REMARKS

Title: AN INSPECTION SYSTEM FOR AIR CARGOES OR VEHICLES

Appln. No.: 10/774,366 **Sheet** 1 of 1

Fig. 2

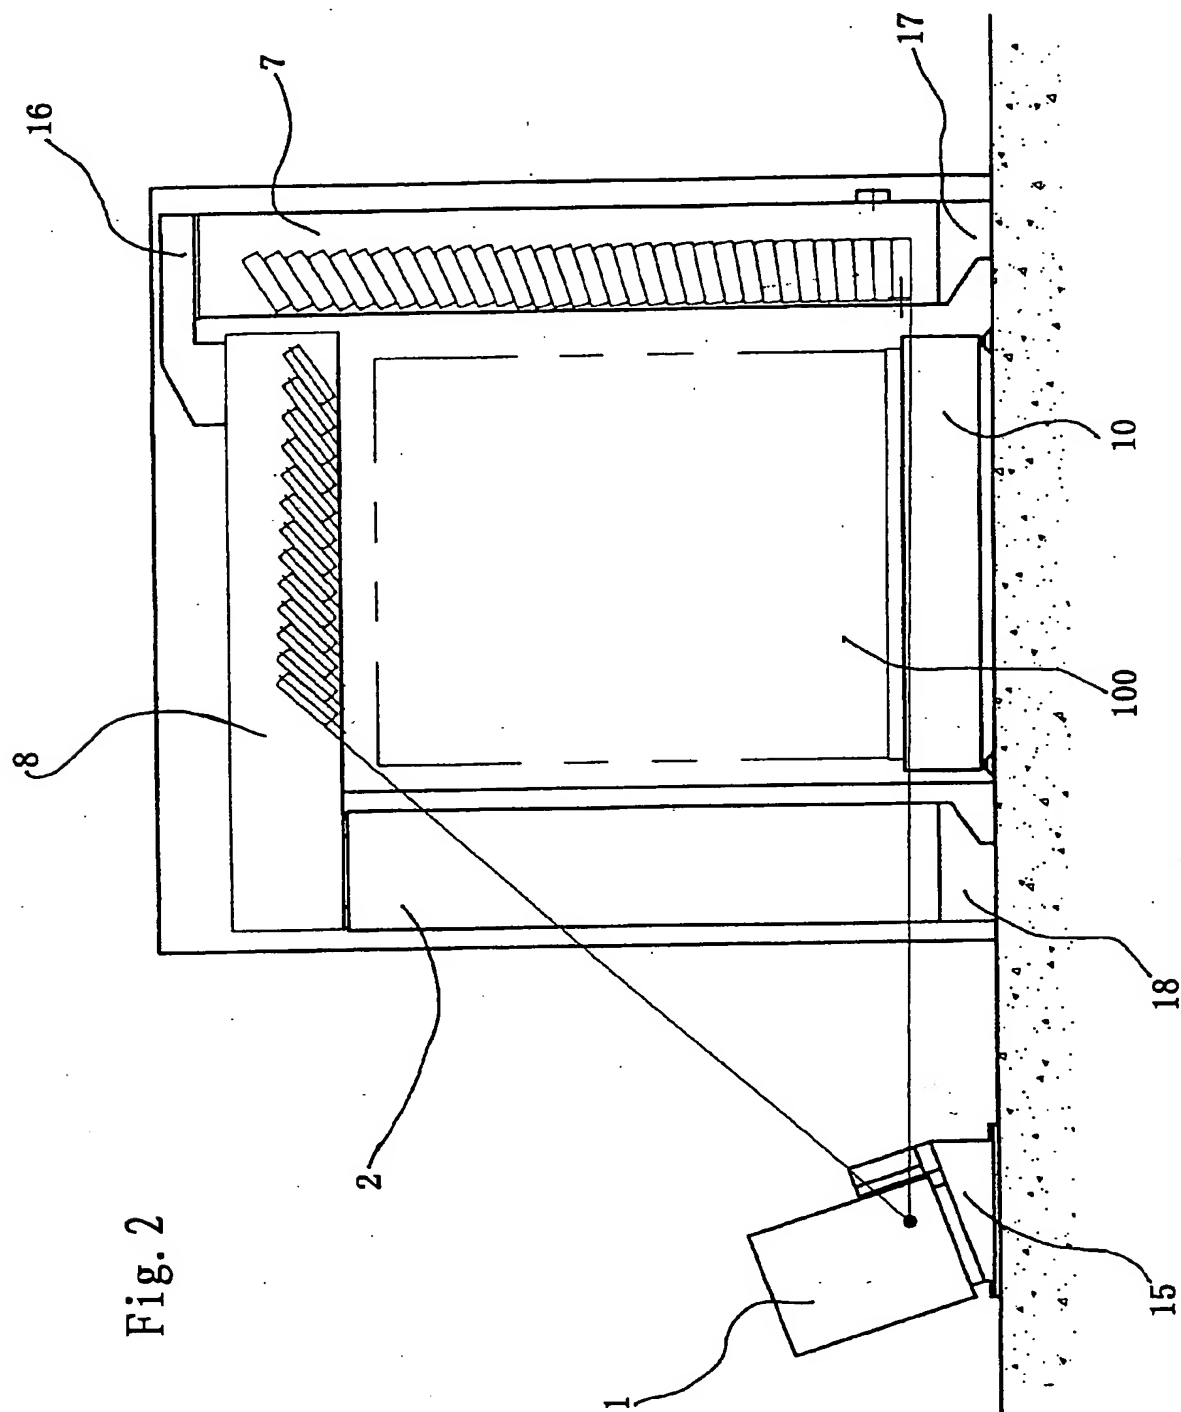
Fig. 2 is amended to better show that the numeric identifier --8-- corresponds to the horizontal detector arm.

One replacement drawing sheet is attached, including Fig. 2. The line extending from the numeric identifier --8-- has been extended to better identify the device.
